Advanced Technical Information

Bulletin #: 2533.1

XAB – Macan Rear Lid Does Not Open/Close

How to check the version for the latch:

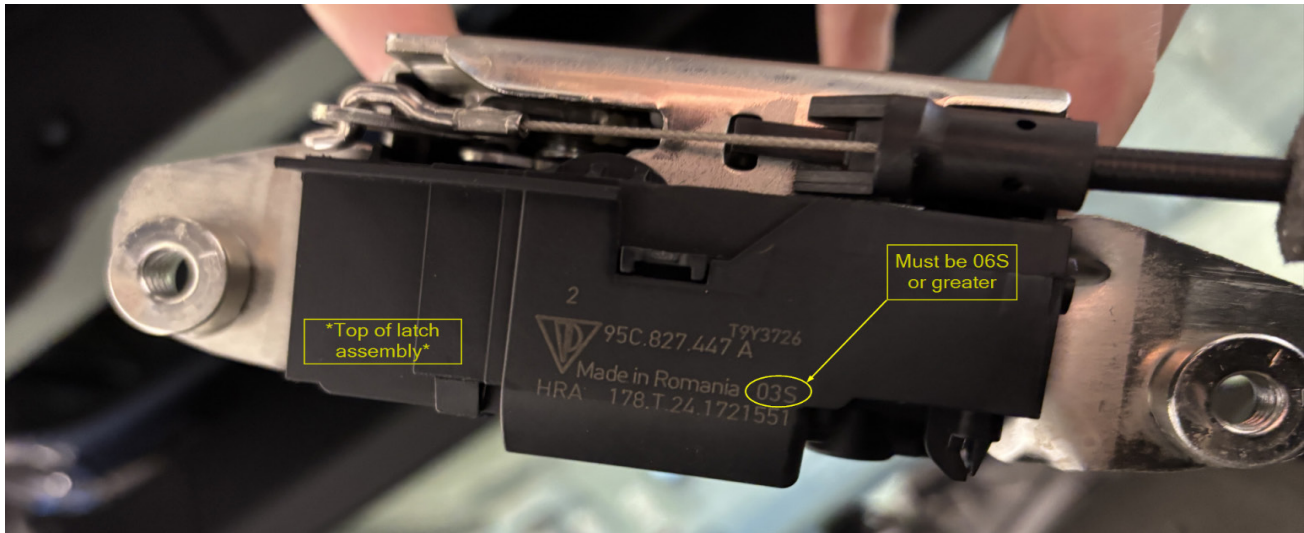
In these cases, check the latch for the rear lid for an indicator of version 06S or greater. If the part has a version from before 06S order a new latch. Once the part is received and the version is verified, replace the latch for the rear lid.
